SERVICE LETTER 274

3000/3450 Rotary Actuator Shaft Key Retainer

Aircraft Makes/Model(s):	Float Model(s):	Compliance: Mandatory	By: MAS
Textron Aviation 180, 182, 185, 206 Maule M-6-235, M-7-260, M-7-260C, MT-7-260, M-7-235, M-7-235B, M-7-235C, MT-7-235, M-7-420A, M-7-420AC	3000A 3450A	Part Number: 1012879 Date: 7/9/2025	Approved:DRH Revision: A

Figure 1

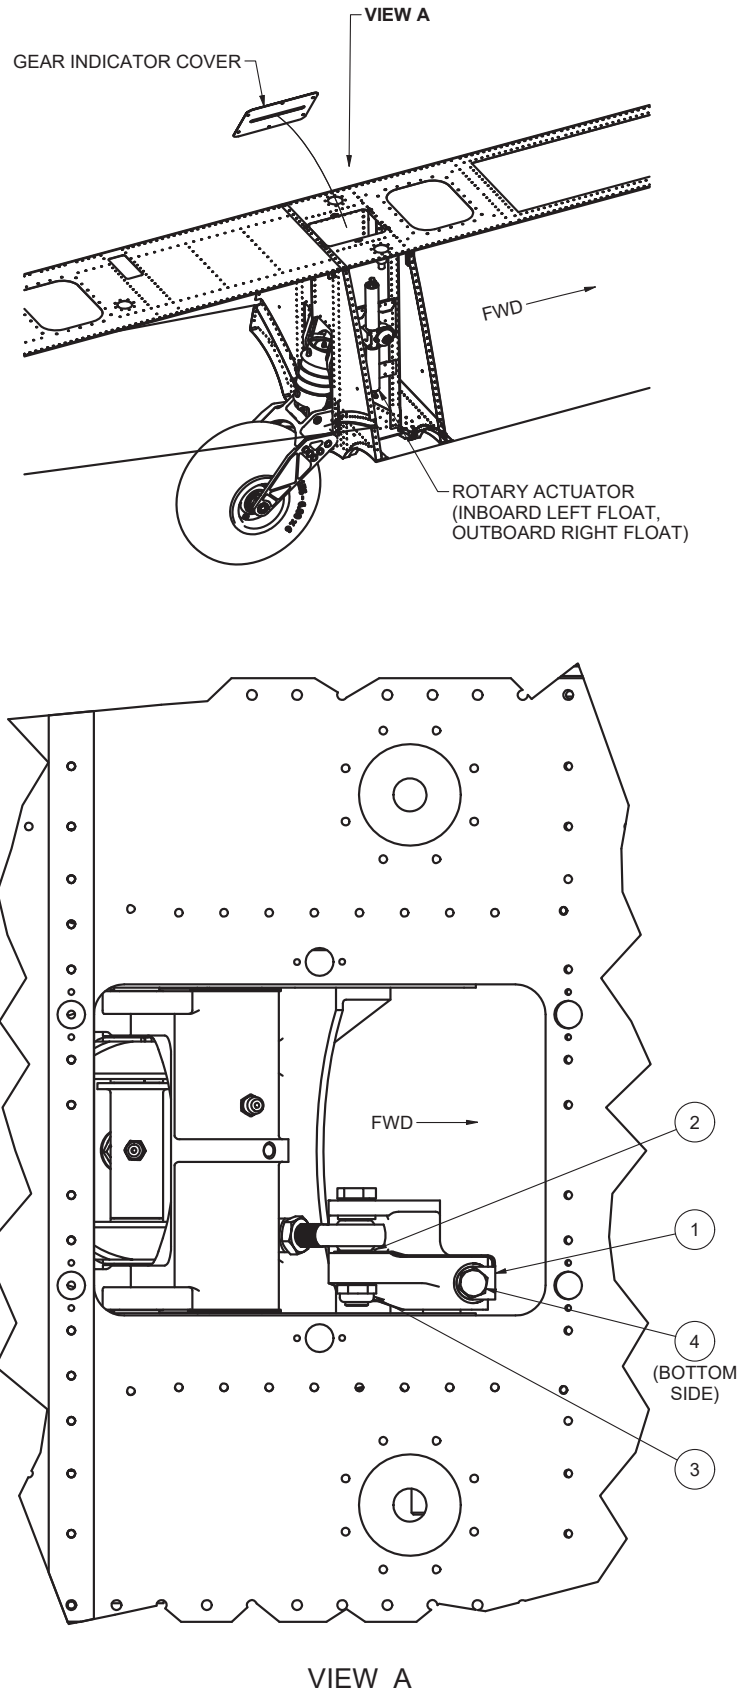
The central rotating shaft within these rotary actuators is splined into landing gear linkage with a square key. The tolerances of these parts are such that it is possible for the key to slip from the keyway, perhaps disengaging the actuator from the linkage and/or damaging nearby components. To remedy this, a retainer entered production in 2025 with float serial numbers:

- Note:** Refer to Figures 1 and 2 for steps 3-9.
3. Remove gear indicator cover (yellow) from float top deck.
 4. Unfasten two bolts through actuator arm. Arm may remain in place on actuator shaft, unless removal would help facilitate steps 5-7.

5. Check condition of key within keyway: Inspect for damage including, but not limited to missing material such as worn edges or ends, corrosion, and deformation (bending, twisting) that could affect its ability to properly engage. Reference part number: MS20066-183.

6. Check condition of rod end linkage and neighboring components: Inspect for general wear or deformation - perhaps resulting from contact with key.
 7. Position retainer (item 1) as shown.

8. Re-fasten arm, retainer, and rod end with existing hardware, except for:
 - a. 0.032"-thick washer (item 2) in place of previously installed 0.063"-thick washer at location shown.

- b. New locknuts (items 3, 4).
 9. Re-install gear indicator cover.
 10. Repeat steps 3-9 for opposite float.
 11. Reset landing gear motor circuit breaker.
